Overview

The purpose of this notification is to communicate a mask change for all production Spartan®-6 FPGA devices and a speed file change for all Spartan-6 –3N speed devices.

Figure 1: Package Topmark

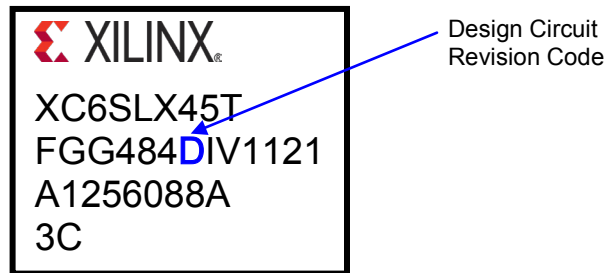
Production Spartan-6 FPGA devices will begin transitioning to a new mask revision. The new mask revision changes the IODELAY2 errata noted in [EN148](#). The mask changes are limited to the IODELAY2 circuit within each I/O. This is considered a minor change and is drop-in compatible. There is no change to functionality relative to the software and documentation, other than the change to the IODELAY2 errata in [EN148](#). The new silicon is bitstream compatible to the current silicon. The new mask revision is indicated by a change in the topmark circuit revision code and by a change in the JTAG IDCODE revision.

Affected devices are identified by the design circuit revision code as shown in the following package topmark.
